## ST ASAPH STREET

### POST CONSTRUCTION ROAD SAFETY AUDIT

Prepared for Christchurch City Council

13 March 2017

Photo 13: Example of RRPM loss

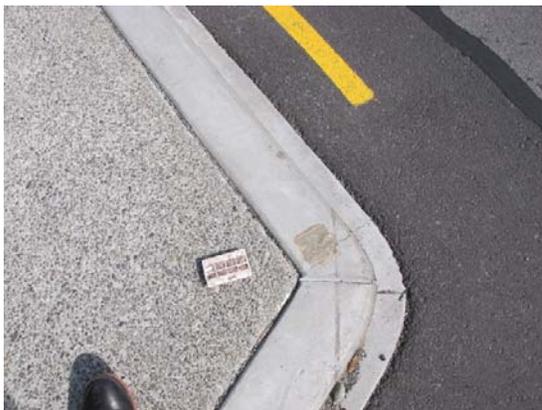
Of concern to the SAT was the high proportion of RRPM's that were absent – evident by the adhesion marks on the kerb top. This would indicate that the attachment adhesive utilised has failed under general use, and the effect of vehicles running over the low profile kerb to access car parks or driving into access ways. This overrun gets worse as more units are knocked off, resulting in a higher level of impacts onto the units, resulting in a greater level of loss.
